Closure Sampling and Analysis Plan for Medical Training Facility

Westover Air Reserve Base
Massachusetts

**RESPONSE TO COMMENTS ON DRAFT AND DRAFT FINAL
CLOSURE SAMPLING AND ANALYSIS PLAN**

**RESPONSE TO AFCEE, WESTOVER ARB AND MASSACHUSETTS DEP
COMMENTS TO THE DRAFT FINAL CLOSURE SAP FOR THE MEDICAL
TRAINING FACILITY SITE, WESTOVER ARB, MASSACHUSETTS**

FIGURE 2.2

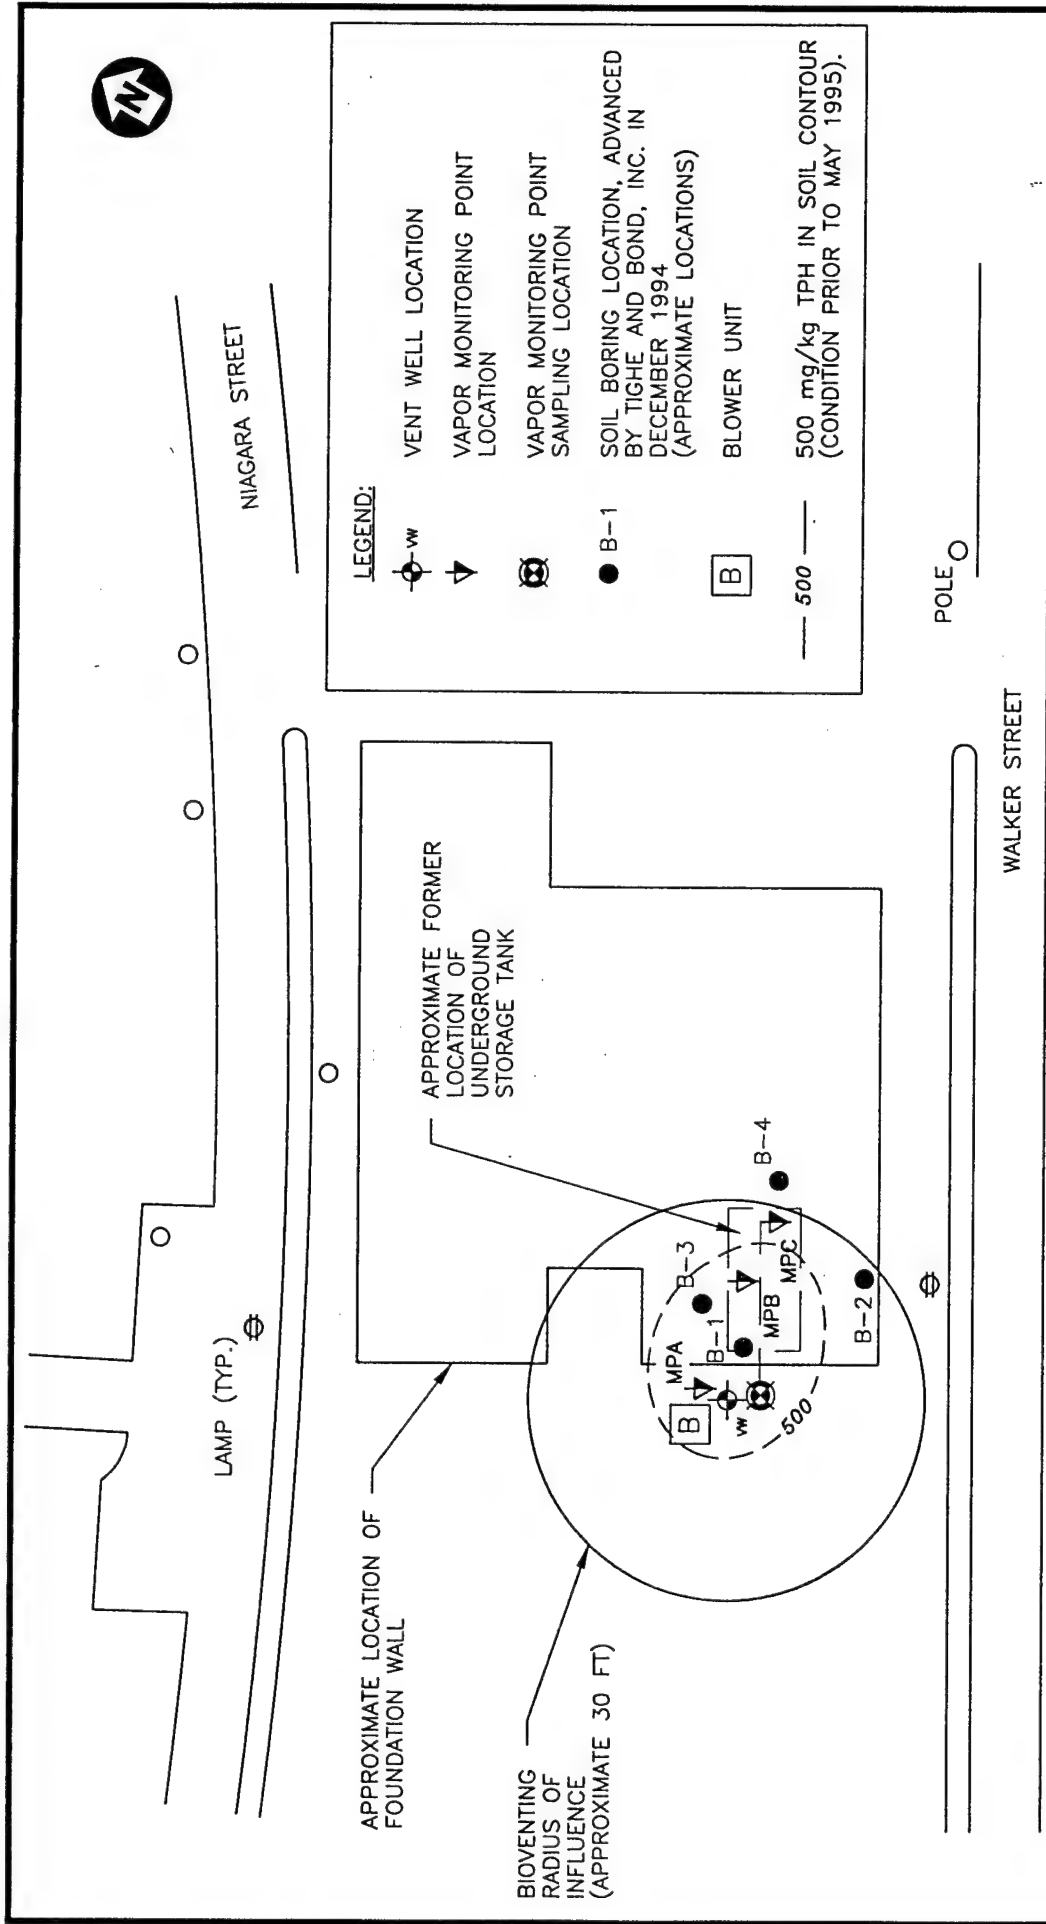
6. *As stated in the report, "the angled boreholes will be drilled at approximately a 45 degree angle, beginning 15 feet away from the building foundation." These boreholes will be completed to 30 feet below the ground surface, and 15 feet within the building foundation." On Figure 4-1 (soil sampling location) it appears that this will give you a sample at 15 feet under the foundation or in the middle of where the UST used to be located. How will the east (far) side of the*

former UST location be sampled? Will the entire "extent of the contamination" be defined for the RAO? The extent of the RAO should be documented vertically and horizontally.

The east end of the former UST area was sampled during an investigation by Tighe and Bond, Inc. in December 1994, location B-4 on Figure 2-2. This soil sample was collected from the 40 to 42 foot depth interval, was analyzed, and detected BTEX compounds below the method detection limit and TPH concentrations of less than 55 mg/kg. In addition, to further document the extent of contamination for the RAO, Parsons ES installed a soil vapor monitoring point (MPC) on the east end of the former UST location in April 1995. This location has shown low concentrations of field analyzed total volatile hydrocarbons (TVH) (less than 75 ppm). Therefore, Parsons ES excluded the collection and analysis of soil from this area because soil and soil gas samples have been collected from this area previously and the results showed low levels of contamination.

FIGURE 2.3

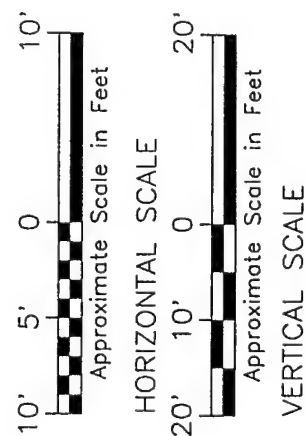
1. *Figure 2.3. All the following refer to the field and lab sample:*
 - a. *Indicate in the legend text that the lab data are gas samples*
 - b. *Are the lab data ppmv or ppm?*
 - c. *Please be consistent in upper/lower case. Field data is ppmv and lab data is PPM.*
 - a. The following change has been made to the legend on Figure 2.3; "soil gas field screening results" has been added to replace "field screening results" in the legend on Figure 2.3.
 - b. A note was added in the legend on Figure 2.3 that laboratory results are in milligrams per kilogram.
 - c. All upper case PPMs were changed to lower case.
2. *Page 4-1, Section 4.1, First line in text. Replace "horizontal" with "angled"*

Done.
3. *Please verify with the Army CoE folks about the proposed procedures to refill the angled borings. I just want to make sure that there is no question about altering the foundation's integrity by improperly refilling the boreholes. They may call for filling with tremie tubes and cement (as an example) or they may say that the holes are so small that there won't be any structural impacts (hopefully). Please get their input in writing.*
